**Waipawa Street for People**

**Preliminary Design Stage Safe System Audit Report**

**Prepared for Central Hawke's Bay District Council**

REVISION 0 – APRIL 2023

Figure 5.3-1 – Change from cycle lane to hatched shoulder

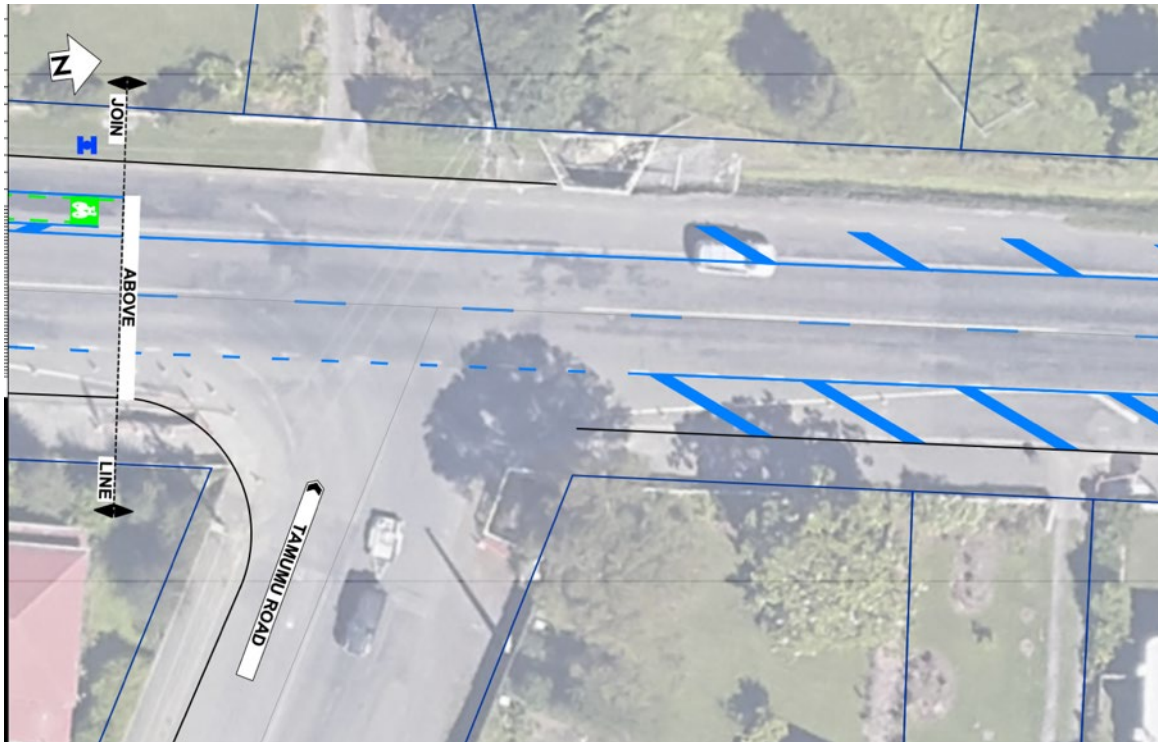
The design proposes the northern extent of the on road cycle lanes to stop at Tamumu Road. It is unclear to the SAT why the facility would stop here given residential properties continue further to the north.

While the proposed hatched shoulder still provides space for cyclists, it does not provide clear guidance as to what this area can be utilised for and could result in poor parking or use of this area as a deceleration lane on approach to the intersections.

It is recommended that consideration is given to extending the proposed cycle lanes further north, potentially to Racecourse Road, to provide improved connectivity for the urban residential sections of SH2.

1. Consider extending the on road cycle lanes to Racecourse Road.

Figure 5.3-2 – Proposed planter boxes

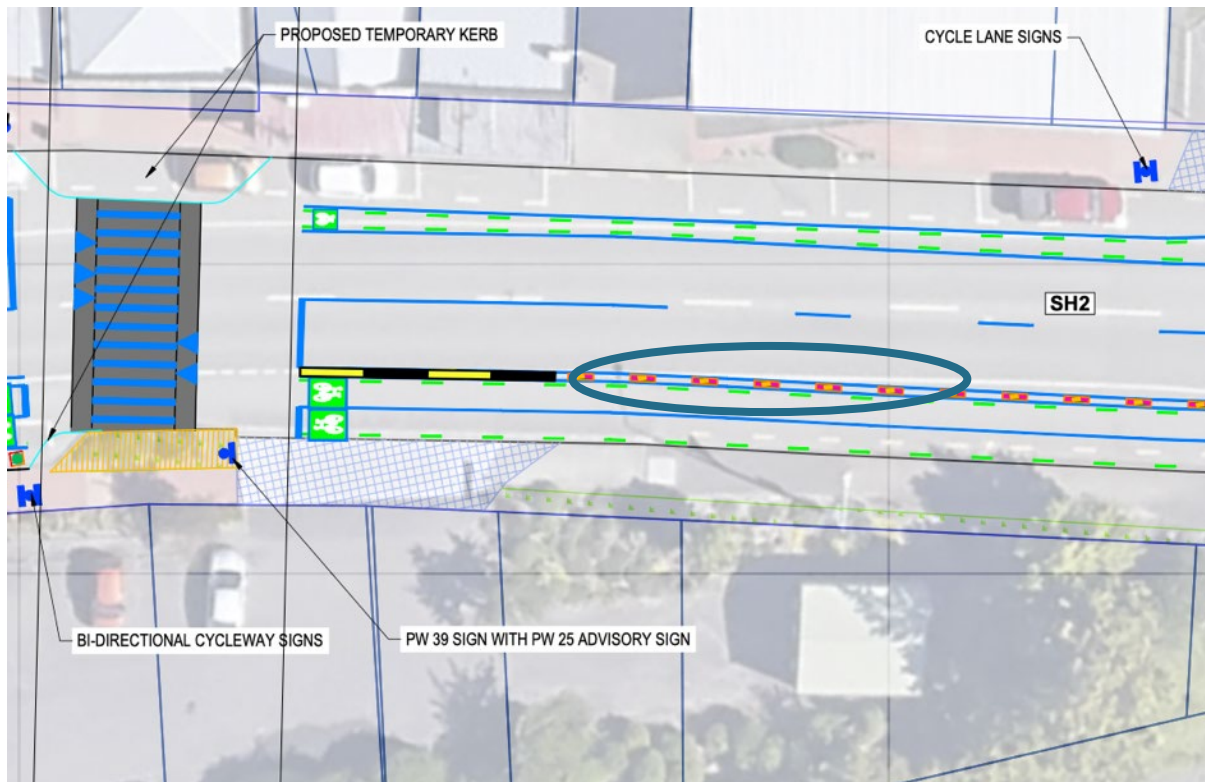
It is proposed to separate the bi-directional cycle lane from the traffic lane with planter boxes. Planter boxes, especially those with spacing between pose a risk of pedal snagging to users immediately adjacent to them. This can result in cyclists falling and receiving serious injuries.

Planter boxes can also have sharp corners which can result in serious injuries if struck. They can also be nudged / bumped out of place by vehicles resulting in them more likely to be struck with them intruding into the cycle lane.

The SAT appreciate there may be an aesthetic value to the planter boxes but they are very narrow and will also potentially create a safety in design issue from a maintenance aspect.

The SAT believe other forms of separation which address the issues above are more appropriate.

1. Consider other forms of physical separation.

**Figure 5.3-3 – Side road limit lines**

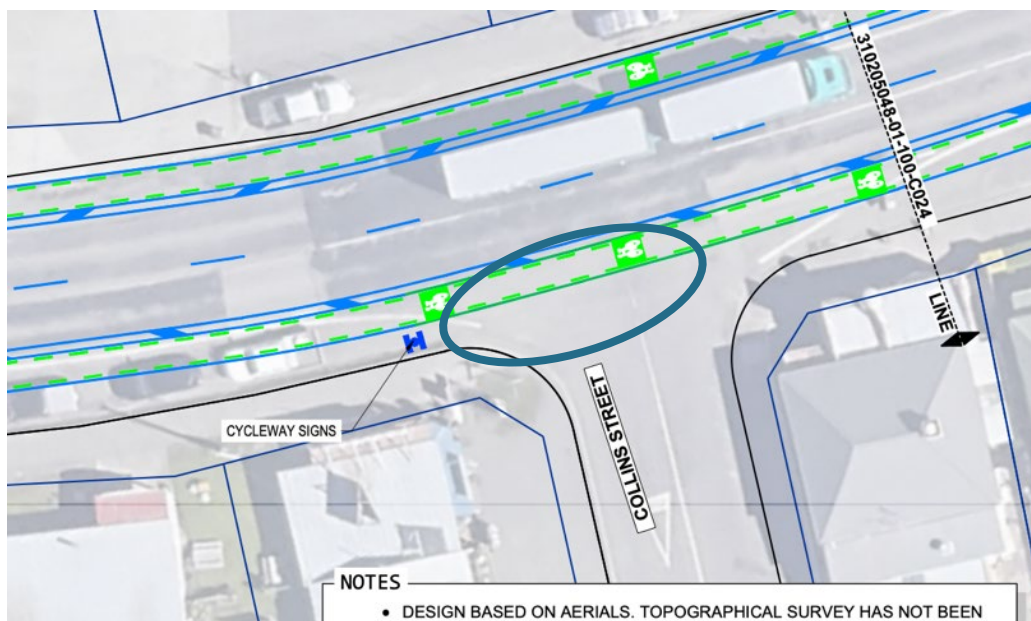
The drawings do not detail changes to limit lines on the side roads. They are currently shown hard up against the cycle lane. These will need to be relocated further back as per MOTSAM. Any changes to the position will require an assessment of the change in sight distance as a result of this. Some intersections may no longer meet the sight distance requirements for a Give Way and may need to be changed to Stop controlled or have additional parking removed to maintain sight distance.

If the limit lines are left hard up against the cycle lane there is a risk of vehicles intruding into the cycle lane and striking cyclists or making them swerve closer to the traffic lane to avoid the vehicle. Either of these could result in serious injuries to the cyclist.

Relocating the limit lines without assessing sight distance and making the appropriate changes could result in side impact vehicle crashes, once again resulting in serious injuries.

1. Relocate the limit lines as per MOTSAM; and
2. Review the sight distance and address any deficiencies appropriately.

Figure 5.3-4 – Distance to rail corridor

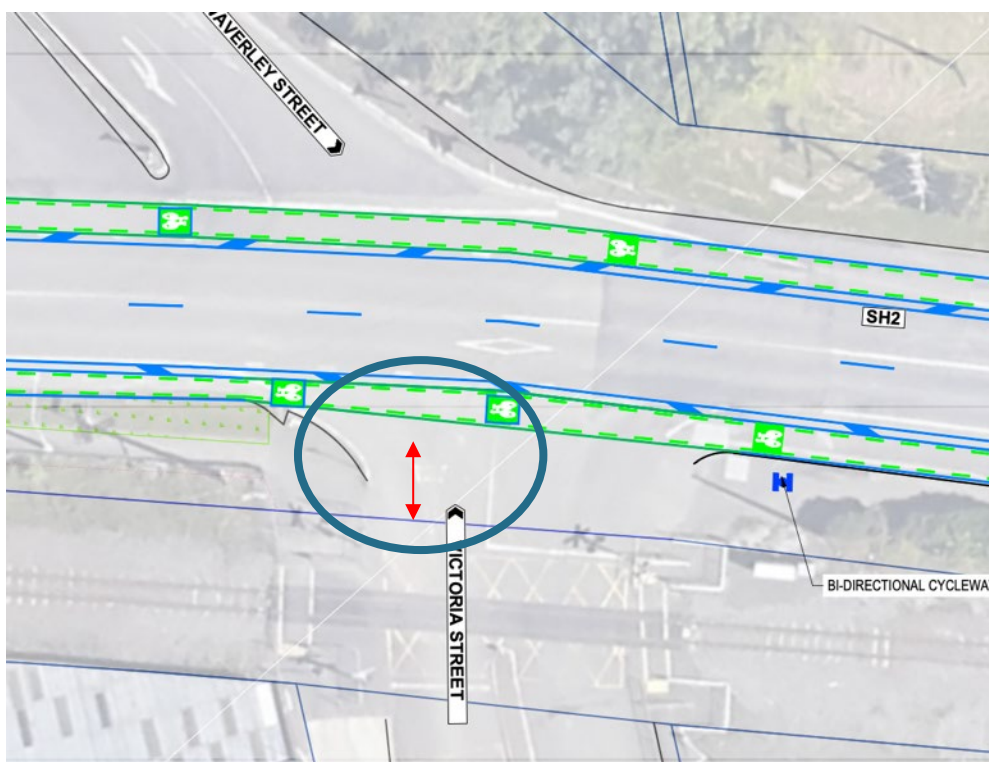
As per Section 5.3.5 the limit lines on side roads will have to be relocated to allow for the cycle lane. At the Victoria Street intersection this will reduce the stacking distance for vehicles between the limit line and the rail corridor. There is currently approximately 8m from the limit line to the hatched area, this will be reduced when the recommendation in Section 5.3.5 is implemented. This should be checked to ensure that vehicles can safely stop in this area. The designers should be aware that Kiwi Rail will require a level crossing safety impact assessment (LCSIA) as a result of any changes to the intersection.

Any crashes which involve rail vs vehicle will result in serious injuries or death.

1. Establish if a safe stacking distance can be provided with the cycle lane in the proposed position; and
2. Ensure that any Kiwi Rail liaison is completed and LCSIA completed if required by them (highly likely it will be).

**Figure 5.3-5 – Areas of high parking demand – areas of concern**

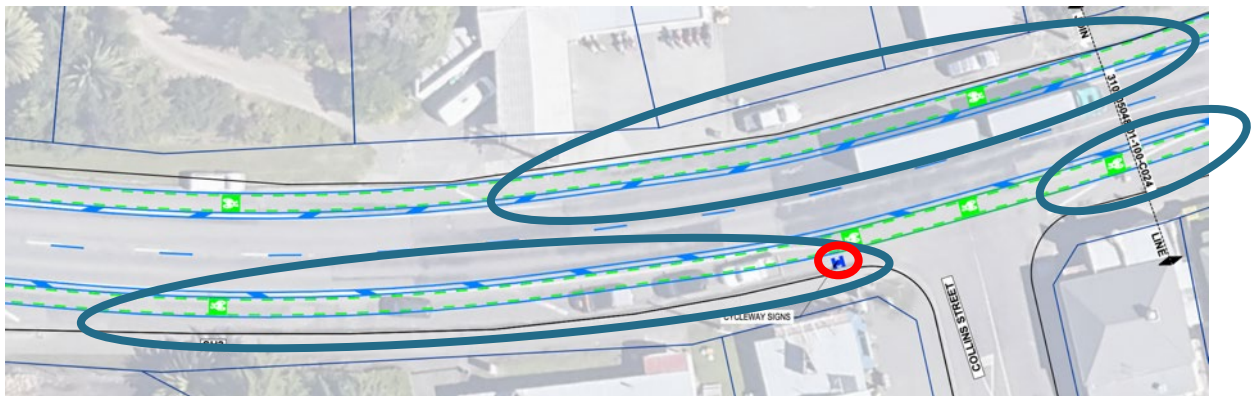
SH2 adjacent to Collins Street has several business (diary, café, bakery) which generate high demand for short term parking. The proposal removes all the parking on the western side (northbound) and possibly removes some on the eastern side. There is a high risk that motorists will park in the cycle lane on the western side while they make short visits to these businesses and with the parking bays not defined on the eastern side they may park poorly and intrude into the cycle lane. Both of these issues could result in a cyclists having to swerve into the traffic lane to avoid parked vehicles which could result on serious injury or death. A survey to understand short term parking demand would be beneficial to inform the project.

Consideration should be given ensuring that some parking is retained on the western side, possibly through recessed parking, and the on street parking is maximised and defined with markings on the eastern side. Note there is also a sign in the parking lane, circled in red, Refer Figure 5.3.5.

1. Consider undertaking a parking survey;
2. Provide appropriate levels of parking and ensure it is defined with marking; and
3. Relocated the proposed sign to the footpath.

**Figure 5.3-6 – Proposed Threshold**

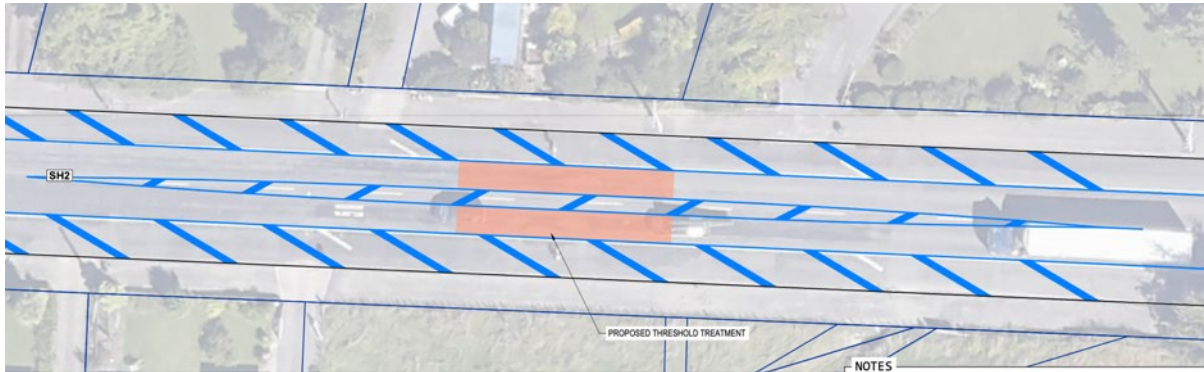
The proposed threshold only details markings and coloured surfacing. This is likely to be ineffective in terms of speed reduction. Consideration should be given to providing more physical channelisation and signage for this threshold to be effective.

1. Consider providing physical channelisation and signage to make the threshold more effective.

Figure 5.3-7 – Waverley Street, angle of left turn out

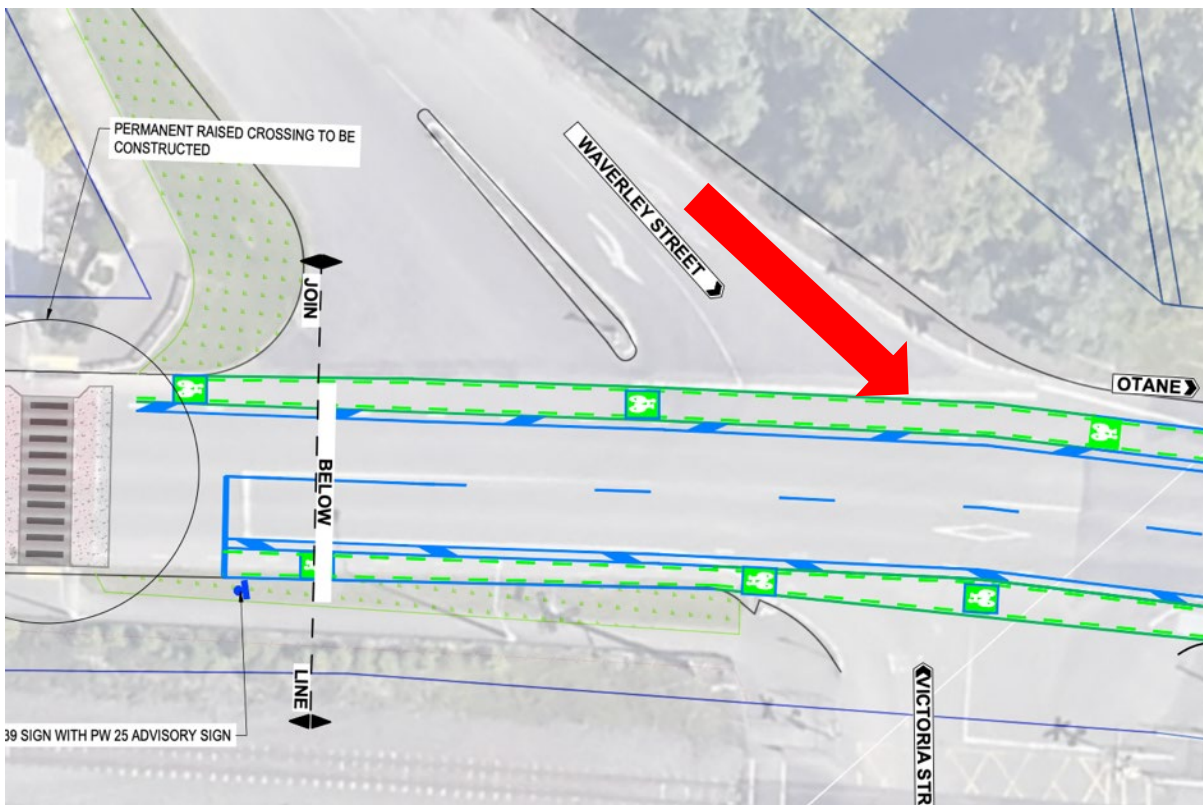
The left turn movement existing Waverley Street is very flat in angle which can result in high speed exits and makes it difficult for motorists to look over their shoulder to check for other road users. This is an existing issue, however with the cycle lane proposed this is a high risk to cyclists who are not as conspicuous to motorists. Any crash involving a vehicle and a cyclists is likely to result in a serious or fatal injury.

Squaring up the intersection would reduce the exit speed and this risk.

1. Consider squaring up the intersection to reduce exit speeds.

**Figure 5.3-8 – Harker Street, Desire line**

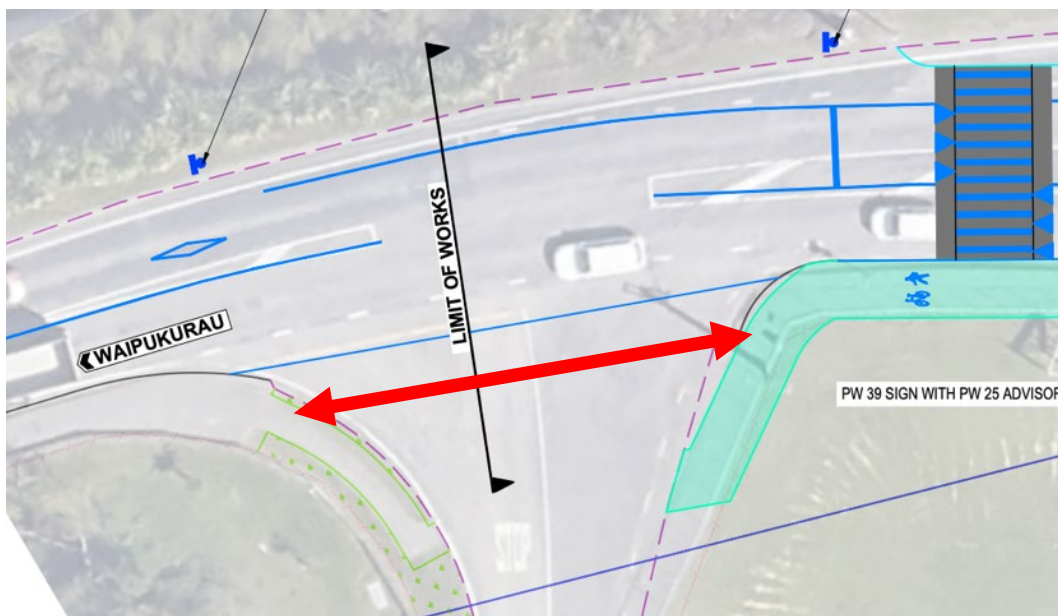
The project finishes immediately prior to the Harker Street intersection. To the south of this is the Waipawa River Bridge which as discussed in Section 5.3.1 leads to the Waipawa to Waipukurau shared path. The SAT believe changes to the Harker Street intersection should be included as part of the Streets for People project.

The natural desire line is across the throat of the intersection. Users are likely to cross here whether there are facilities or not. The installation of a splitter island with a refuge would provide benefits for users to provide protection and a two part crossing. It is understood that there are potential changes to the use of Harker Street which may allow this crossing point to be designed differently. It is recommended that this be taken into consideration as part of this project to improve connectivity.

1. Include this intersection within the project scope and introduce facilities to improve the safety and level of service for pedestrians and cyclists.

Figure 5.3-9 – Location of the proposed southern RSP vs desire line

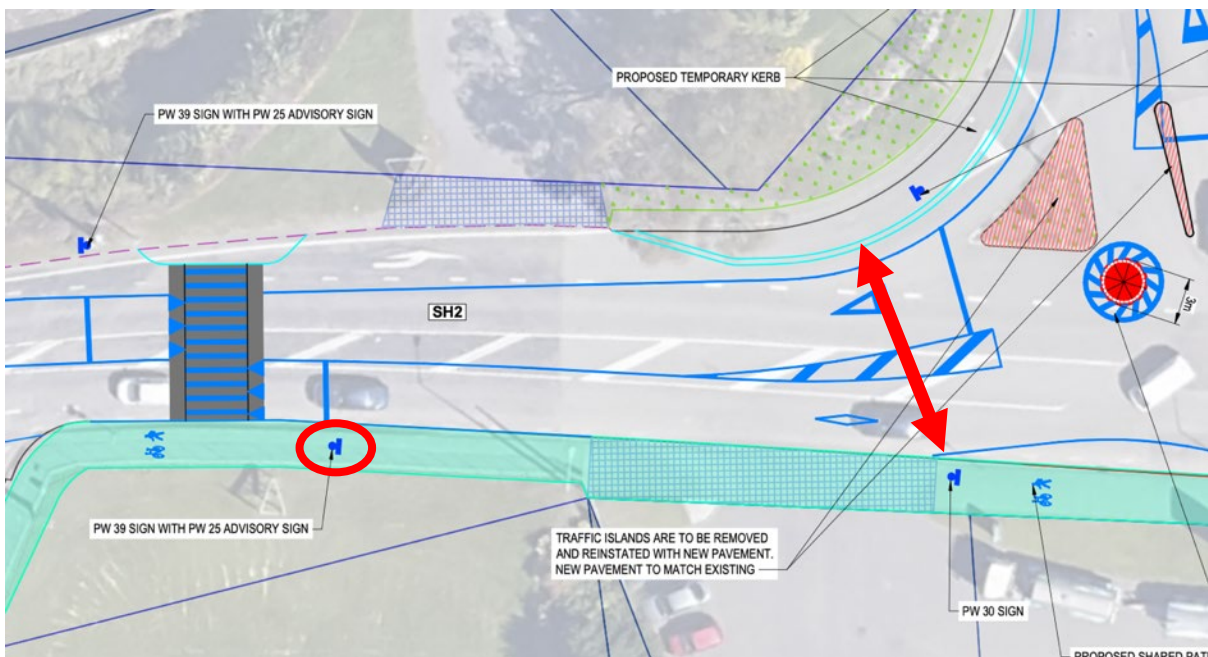
The southern RSP is some distance from the desire line for pedestrians, and also further back than the RSP's on the other approaches to the roundabout. This will likely result in pedestrians crossing closer to the desire line where there are no facilities for them (Refer the double headed arrow in Figure 5.3.9) and also approach speeds to the roundabout on this leg being higher than the other legs.

The combination of higher approach speeds and pedestrians crossing without any form of pedestrian facilities could result in pedestrian injuries. The uneven entry speeds at a small diameter roundabout could also result in an increase in intersection related crashes and the associated severity of them. Having a formal pedestrian crossing at a location where there is low demand can also lead to complacency with motorists.

The SAT understand that the location of the full width RSP is dictated by the existing vehicle crossings. Given the proposed crossing point is likely to have the lowest demand for pedestrians other options of speed management for the approach combined with other pedestrian facilities closer to the desire line could provide a better level of service for pedestrians and safety.

The PW 39 sign (Refer Figure 5.3.9) is positioned in the middle of the shared path. This is a hazard to cyclists and could result in injuries. Care should be taken to position all signage in the shared path so as to avoid creating hazards to the path users.

1. Consider alternative forms / location of speed management on the approach;
2. Consider providing alternative forms of pedestrian facilities closer to the desire line; and
3. Ensure that signs are placed so as not present a risk to path users.

Figure 5.3-10 – Signage for approaching vehicles

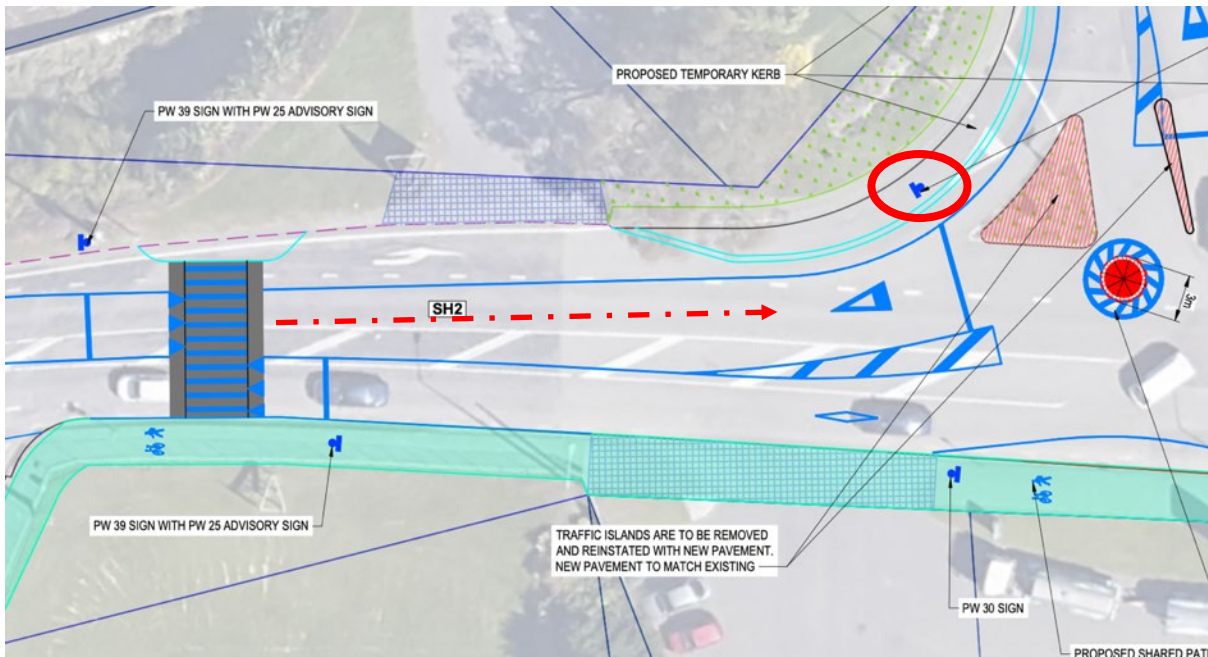
The proposed roundabout has no supplementary Give Way (RG 6R) signs, and being a small diameter mountable roundabout has no chevrons on the central island. Vehicles approaching on the southern approach are unlikely to see the RG 6R as they approach, as indicated by the red dashed arrow in Figure 5.3.10. This could result in poor compliance for giving way at the roundabout and resultant injury crashes.

Consideration should be given to installing supplementary Give Ways on the splitter 'islands' to provide better warning to approaching vehicles.

1. Consider installing supplementary signage on the splitter 'islands'.

Figure 5.3-11 – Risk of straight lining the roundabout

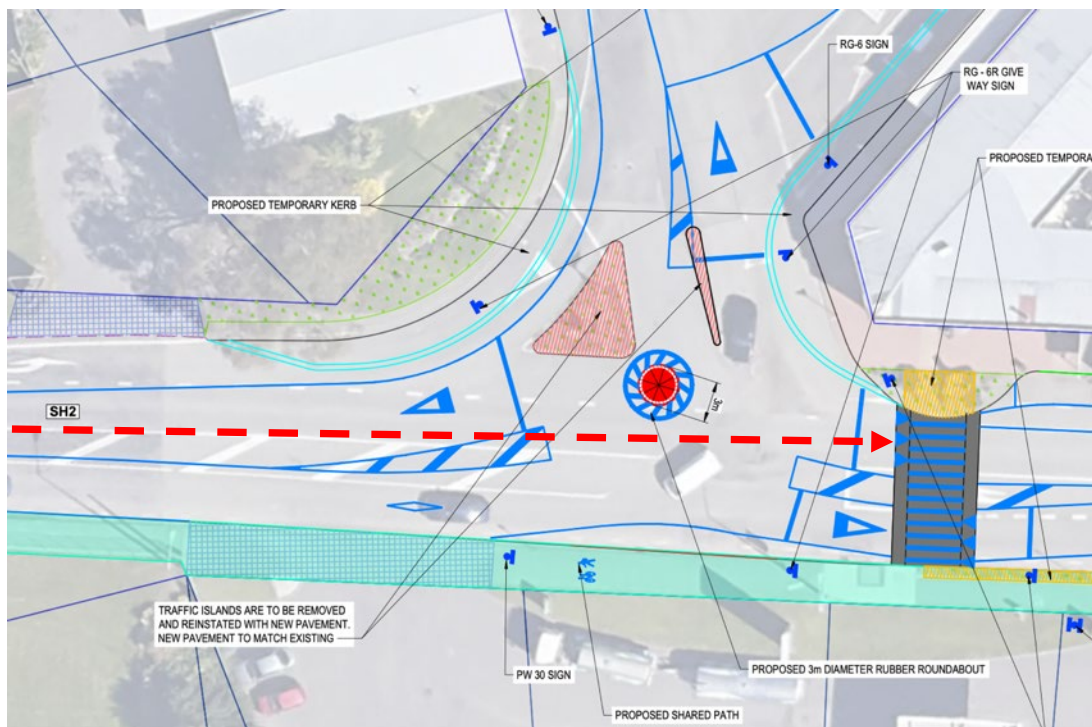
The splitter islands on all approaches to the roundabout are only hatched road marking. These will not manage approach angles to the roundabout. There is a risk in off peak periods that a small number of motorists may decide to straight line the roundabout rather than circulate around the island resulting in high speeds and risk of crashes with other road users not expecting this behaviour.

Consideration should be given to forming the islands with some form of physical product such as temporary rubber islands or delineators. This would also provide locations for signs to be installed as per Section 5.3.13.

1. Consider forming physical splitter islands.
